White Paper

Communication Between Redundant Safety Divisions and Between Safety and Non-Safety Systems

Attachment 1 – Recommended changes to IEEE Std. 7-4.3.2

Annex E, Communication independence

Figure E.1—Communication between safety channels (One-way communication)

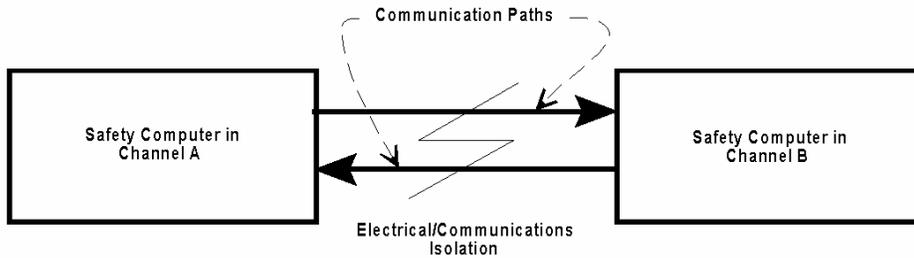
Communication between computers in different safety channels may be desired for such purposes as voter logic or time stamp synchronization. Upon a failure of the communication, the preferred failure state **shall** be set if one has been identified. Figures E.1 and E.2 depict ways in which this can be accomplished.

Figure E.1 depicts broadcast communication between a safety computer in channel A and a safety computer in channel B. The one-way communication path provides a point of software isolation. The physical link(s) between the computers provide electrical isolation. This isolation may be accomplished optically (i.e., fiber optic cable or optical isolators). Communications isolation is provided through the broadcast communication.

The buffering circuit provides an interface allowing acknowledgment or no acknowledgment of data transfer between channels, collision avoidance, etc. It serves as a buffering feature between the communications link and the safety function to ensure integrity of the safety function. The buffering circuit should be separate (e.g., at a minimum on a different board) from the processor performing the safety function. The buffering circuit may be another processor, memory card(s), etc. V&V activities **shall** include the buffering circuit. The physical link between the buffering circuits **serves** as the point of electrical isolation.

Figure E.2—Communication between safety channels (two-way communication)

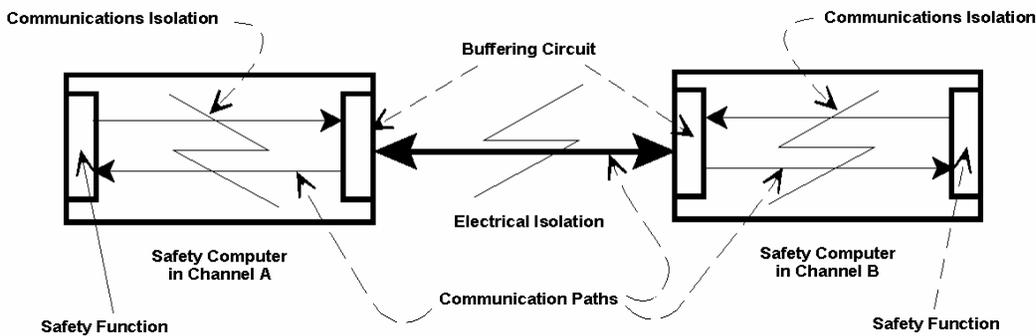
Figure E.2 depicts a method with two separate points of isolation, one electrical and one for communications. This method allows two-way communication between safety computers, as long as a buffering circuit is employed.

The broadcast communication link between the safety function and the buffering circuit serves as a route for data to be sent out by the safety computer. The separate communication from the buffering circuit allows the safety function processor to receive data from another channel. The process of requesting and receiving data from another channel shall not result in loss of either of the safety functions.

Figure E.3—Communication between safety and nonsafety computers (one-way communication)

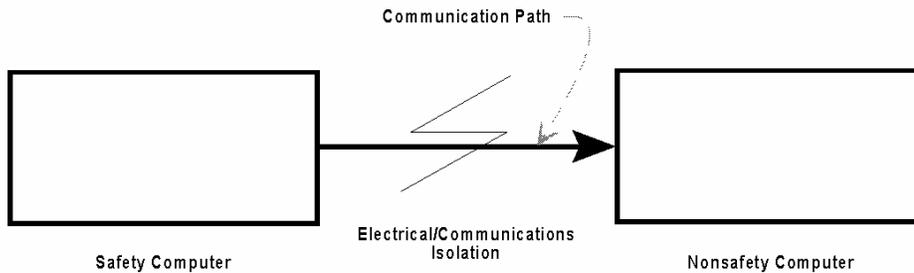
Figure E.3 graphically shows a broadcast communication between the safety computer and the nonsafety computer. The one-way communication path provides for communication isolation. The physical link(s) between computers provides both electrical and communications isolation as required. Electrical isolation may be accomplished optically (i.e., fiber optic cable or optical isolators). Communications isolation is provided through the broadcast communication path.

Figure E.4—Communication between safety and nonsafety computers (two-way communication)

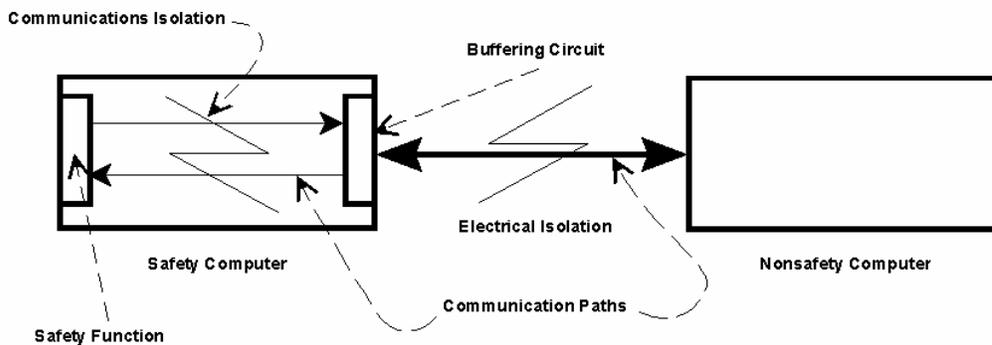
Figure E.4 depicts a method with two separate points of isolation, one electrical and one communications. This method allows two-way communication between the safety computer and the nonsafety computer, as long as a buffering circuit is employed in the safety computer. Use of this method may be necessary when a separate computer is used for test and calibration purposes.

The buffering circuit provides an interface allowing acknowledgment or no acknowledgment of data transfer between channels, collision avoidance, etc. It serves as a buffering feature between the communications link and safety function to assure the integrity of the safety function. The buffering circuit should be separate (i.e., at a minimum on a different board) from the processor performing the safety function. It may be another processor, memory card(s), etc. V&V activities **shall** include the buffering circuit. As required, the link between the buffering circuit and the nonsafety computer provides electrical isolation.

The broadcast communication link between the safety function and the buffering circuit serves as a route for data to be sent by the safety computer. The process of sending data **shall** not result in loss of the safety function. The broadcast communications link from the buffering circuit to the safety function is necessary when a separate test and calibration computer is employed.

Figure E.5—Communication between safety and nonsafety computers

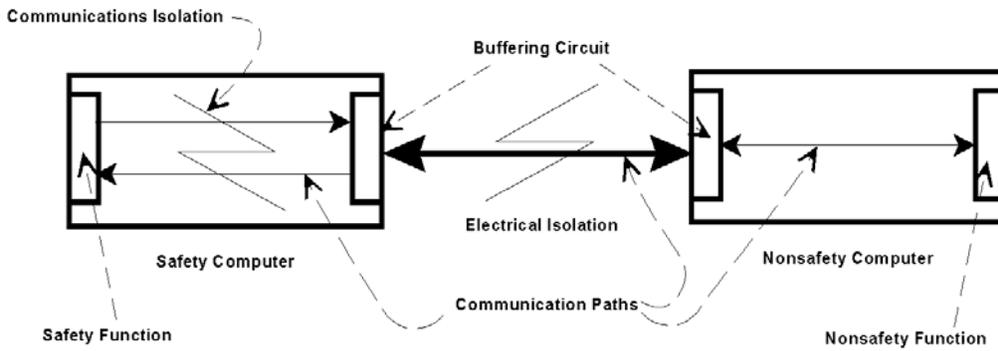
Figure E.5 is similar to figure E.4 except that an optional buffering circuit and communication path is employed in the nonsafety computer.
